Service Bulletin

Bulletin No.: 15-NA-072

Subject: Intermittent Service SIR System Indicator On and/or DTC B0014-04 Driver Seat Side Air Bag Deployment Loop Open

Brand:	Model:	Model Year:		VIN:		Engine:	Transmission:
		from	to	from	to		
Chevrolet	Spark EV	2014	2015	SOP	FC810077	All	All

4322029

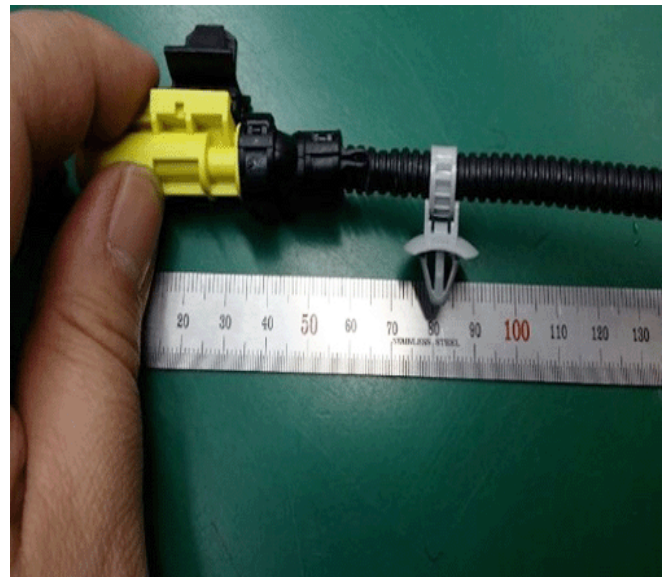
4. Push in the cable locker using a pick or awl as illustrated above to loosen the cable tie so that it can be moved.

4322446

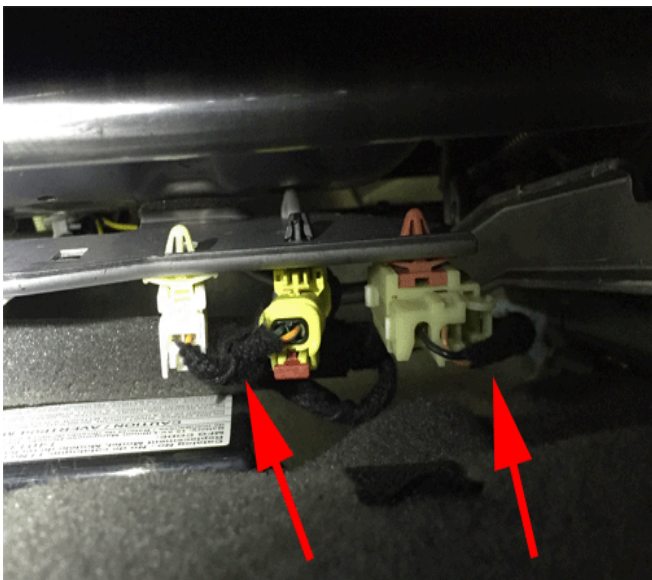
6. Re-tighten the cable tie in its new location and install the cable tie back on the wire connector mounting plate.
7. Gently press the wire connector mounting plate so that it is parallel to the seat pan.
